**BOWERS ELEMENTARY SCHOOL
MANCHESTER, CONNECTICUT
STATE PROJECT NO. 077-0239 RNV
ADDENDUM NO. 7
March 2, 2022**

I. REVISIONS TO SPECIFICATIONS

A4.01

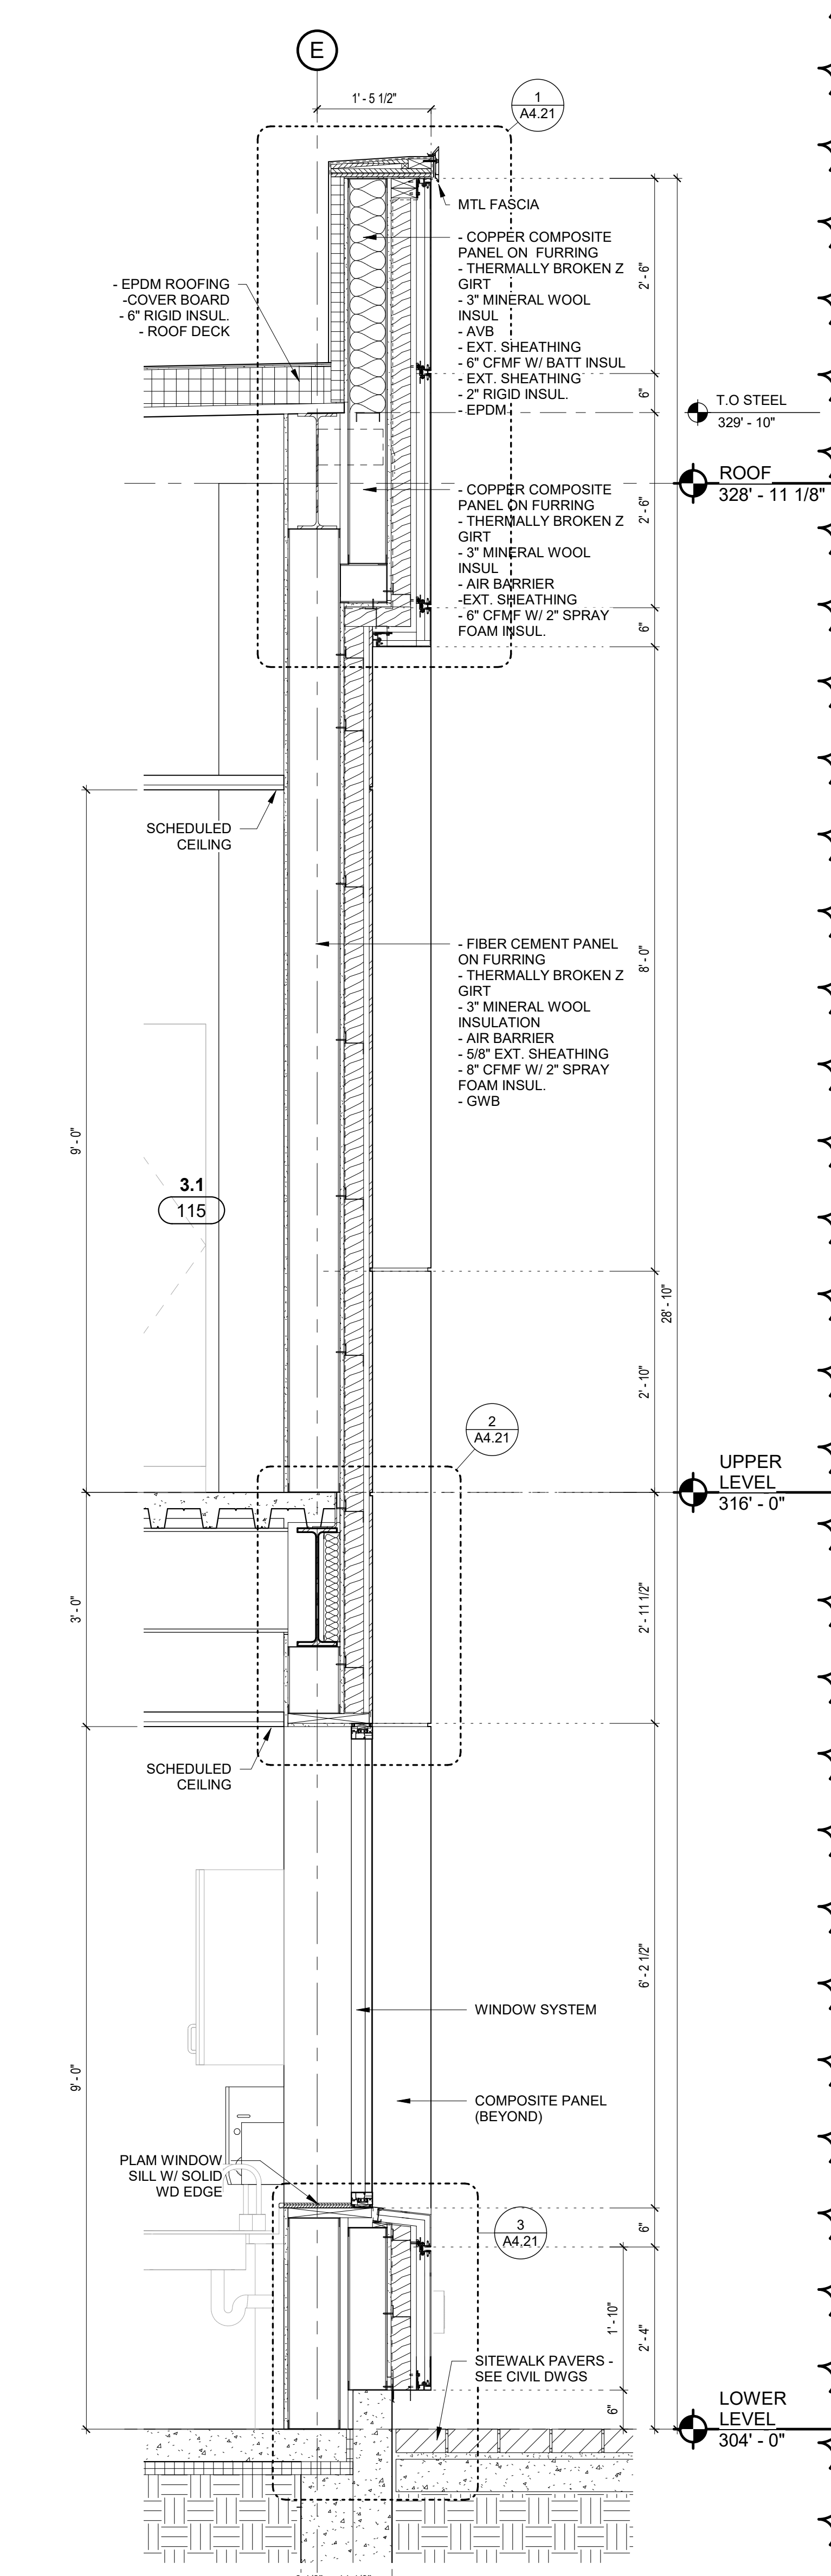
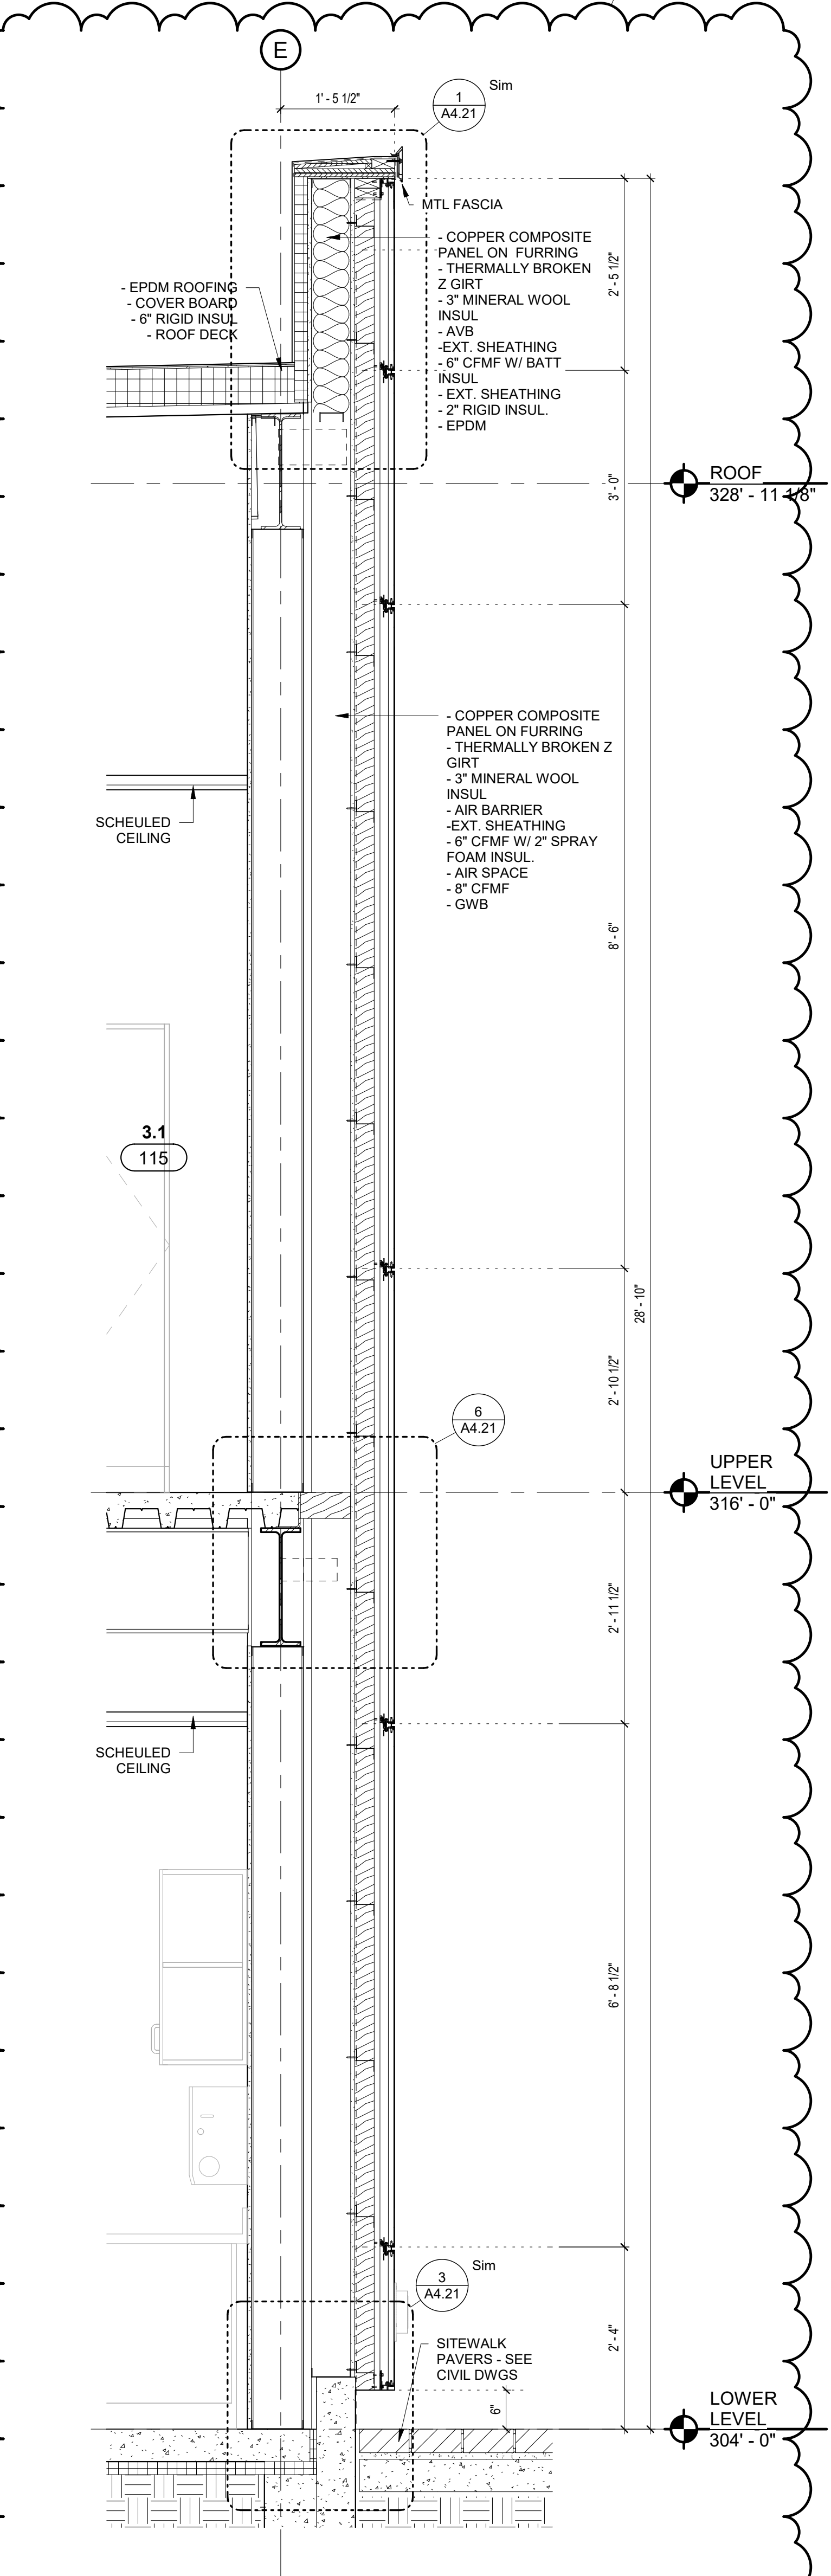
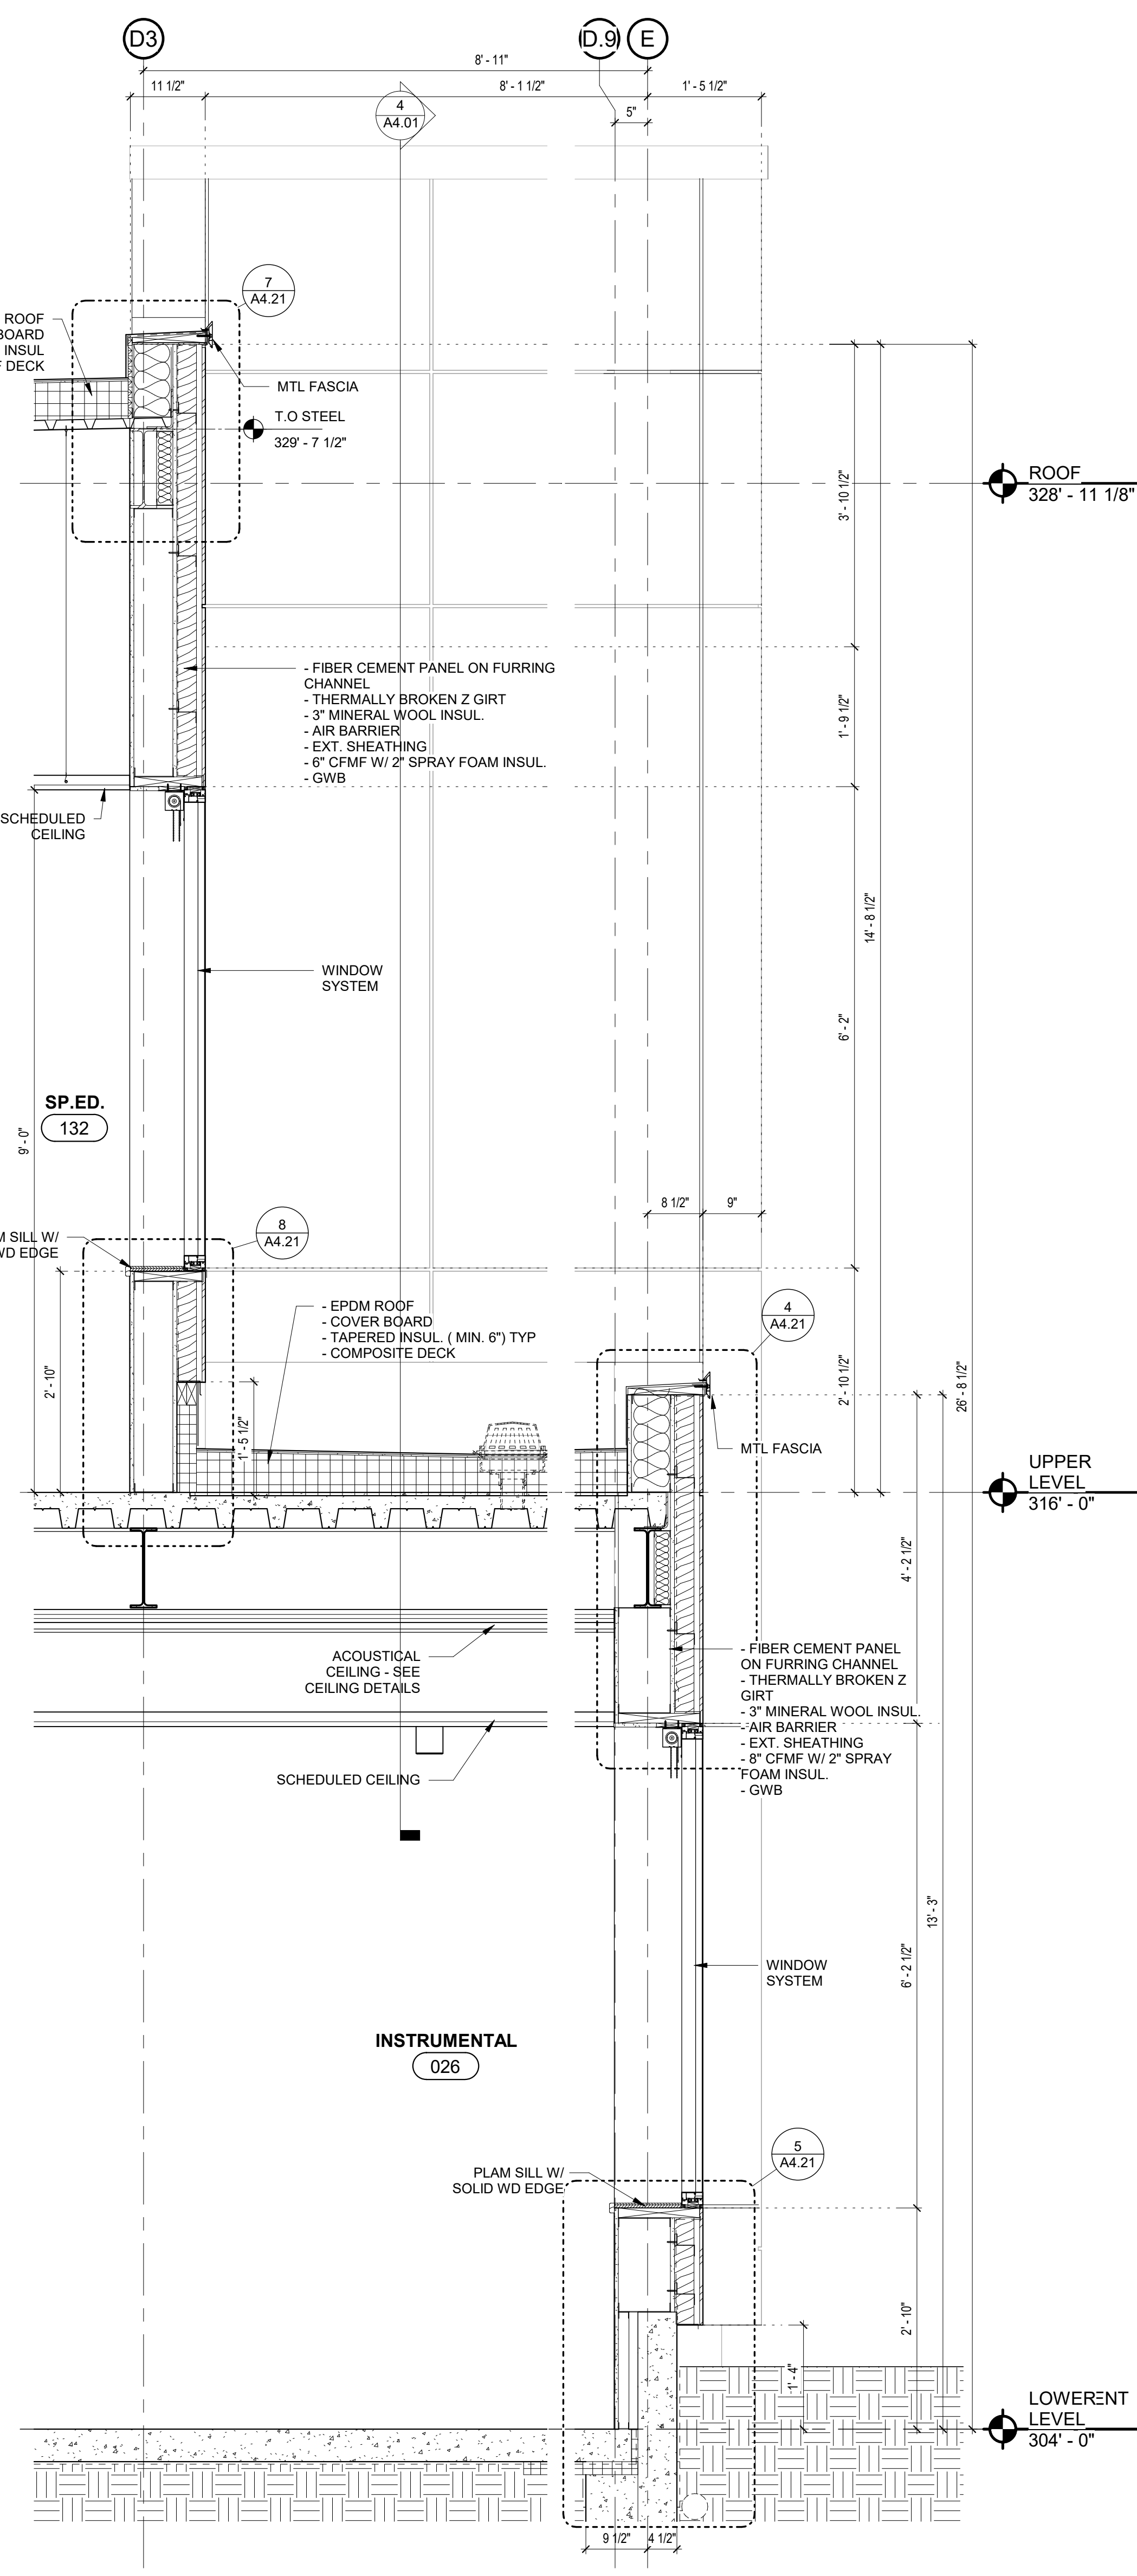
7. A4.01;
- Replace sheet with attached A4.01.
8. A4.21;
- Replace sheet with attached A4.21.
9. A4.22
- Detail 4; Refer to revised sketch PB_SKA-05R
10. A4.24
- Detail 2; Refer to revised sketch PB_SKA-05R
11. A4.31;
- Replace sheet with attached A4.31.
